October 30, 1985
ST-HL-AE-1467
File No.: G9.17

South Texas Project
Units 1 and 2
Docket Nos. STN 50-498, STN 50-499
Information Concerning the Supplementary
Containment Purge Subsystem

Attachments: Annotated FSAR pages regarding the Supplementary Containment
Purge Subsystem

Figure 6.2.4-1

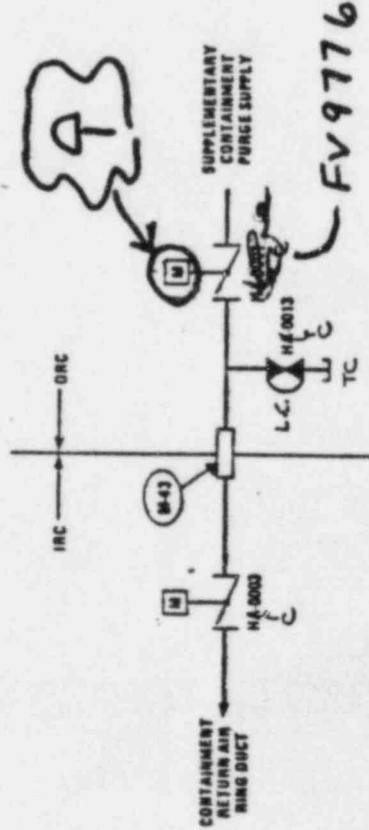
THIS VALVE COULD BE OPENED DURING NORMAL OPERATION AS NEEDED

CONTAINMENT PENETRATION NO. M-43

DESCRIPTION: SUPPLEMENTARY CONTAINMENT PURGE
SUPPLY
SYSTEM: RCB SUPPLEMENTARY PURGE SUBSYSTEM

Figure 6.24-1

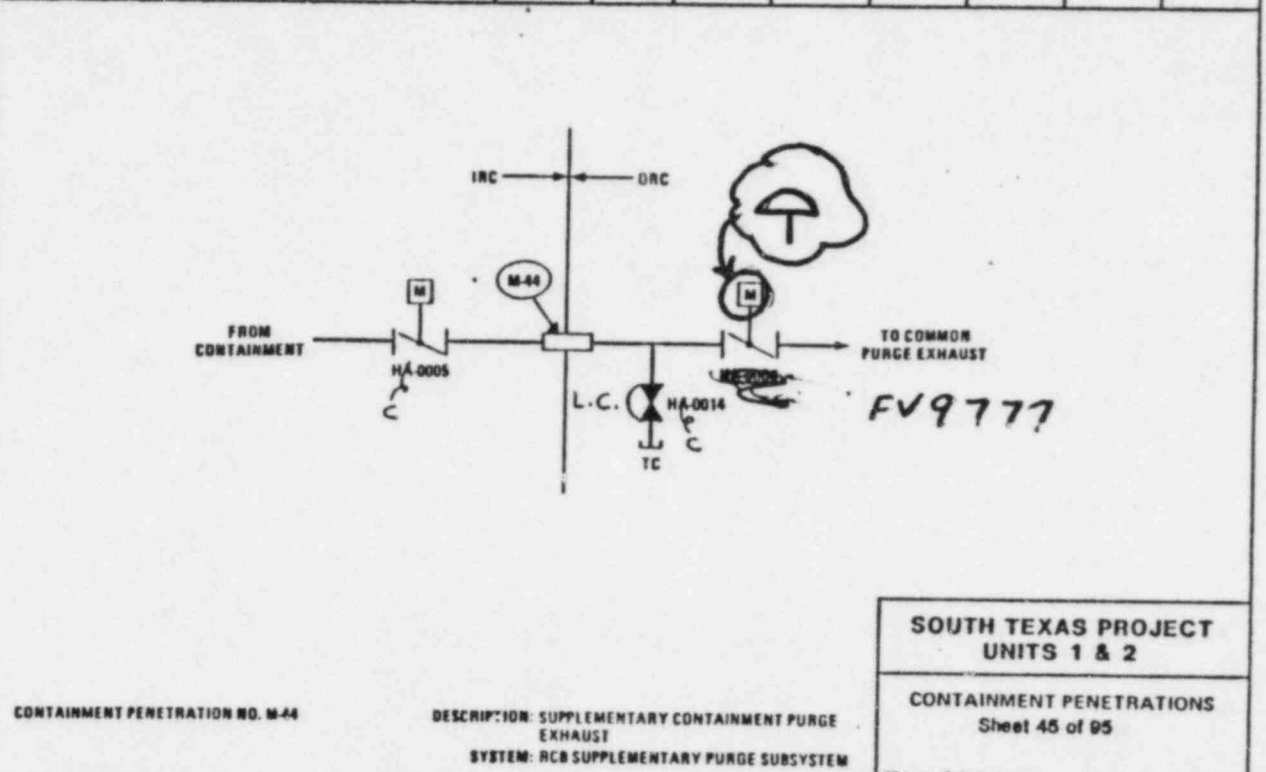
CONTAINMENT PENETRATION NO. M-44

DESCRIPTION: SUPPLEMENTARY CONTAINMENT PURGE EXHAUST
